BCA & Access Assessment Report

Project Atlas Data Centre
10 Roberts Rd, Eastern Creek NSW

Revision A

13 April 2026

Figure 2: Rise in Storeys Calculation Building 1

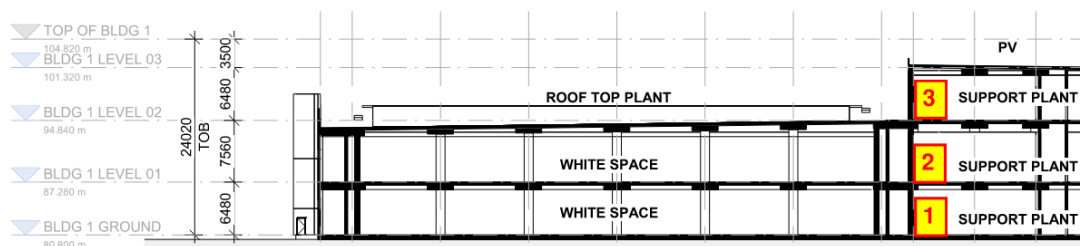
Comment: This Building 1 has a rise in storeys of five (5) based on the internal height of Level 01 & 02 being greater than 6m; and the Building 2 has a rise in storeys based on the internal height of the Roof Level lift lobbies being greater than 6m – see assessment diagrams below.

Figure 4: Typical Fire Wall proposed on each floor of Building 1

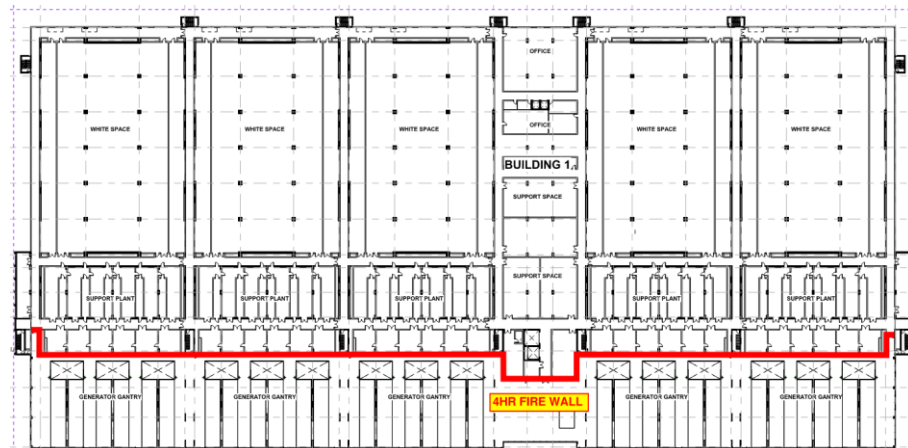
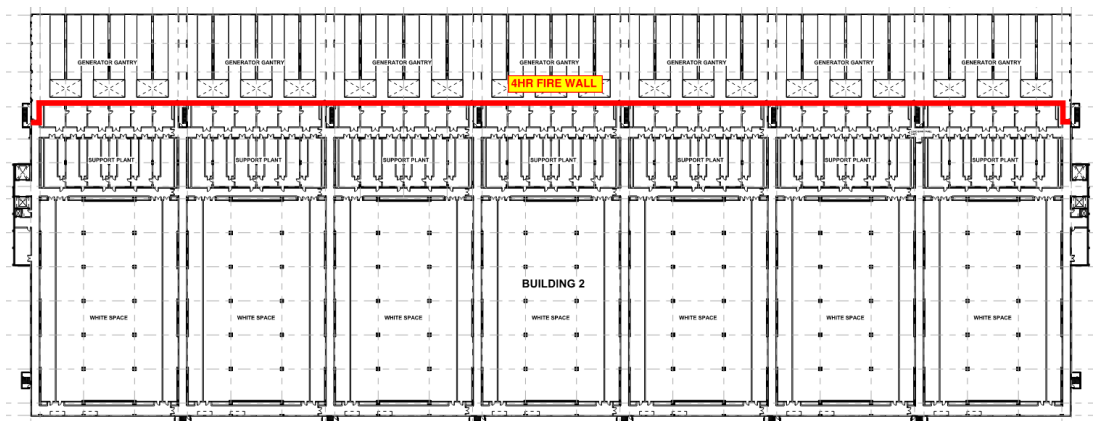
C3D3	General Floor Area and Volume Limitations: The building is to achieve fire compartment sizes not in excess of the DtS requirements of this clause as noted above and in Table C3D3. Comment: It is noted that the proposed fire compartments on each level of each of the two buildings exceed the maximum limitations of Table C3D3 for a Type A Construction Class 7b building. It is further noted that large Isolated Building designation is not proposed. It is understood that each level of the Data Centre building will be divided into 2 fire compartments, consisting of the Data Halls and Plant Rooms in one compartment and the Generator Gantry structure in a second compartment – see example in Figure 4 below. It is understood that a Performance Solution is proposed by the Fire Engineer to address the oversize fire compartments based on the level on the fire separation proposed within each fire compartment.

Figure 5 – Typical Fire Wall interface with Fire stairs

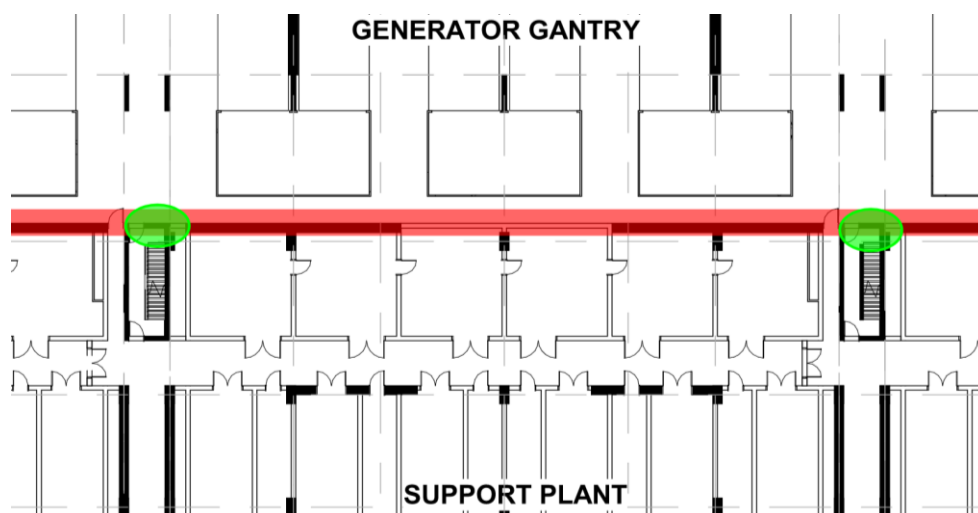
Comment: As noted in C3D3 above the Data Centre buildings are proposed to be separated into two distinct fire compartments on each floor to separate the Generator Gantries from the remainder of each storey. The proposed 4hr Fire Walls separating the generator gantries interface with the fire stair risers (which incorporate 1 hr fire doors). The typical interface details is identified in Figure 5 below. Given that the fire stairs (and the fire doors incorporated in it) do not require the same fire rating and level of protection as the fire wall, a Performance Solution will be required from the Fire Engineer for the proposed detail in both buildings.

Figure 5 – Typical Bld.2 Roof Level Egress Configuration

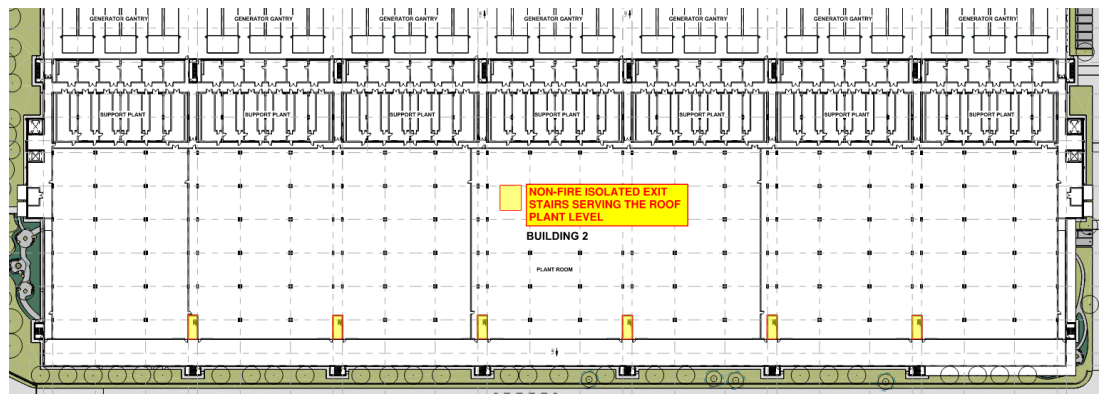
Comment: The proposed non-fire isolated exit stairs serving the Roof Level plant in Building 2 discharges onto the Level 03 slab below. This discharge configuration does not comply with the requirement of D2D14 for the non-fire isolated exits to discharge at a level of road or open space and as such their configuration will need to be addressed as a Performance Solution by the Fire Engineer - see typical detail in Figure 6 below:
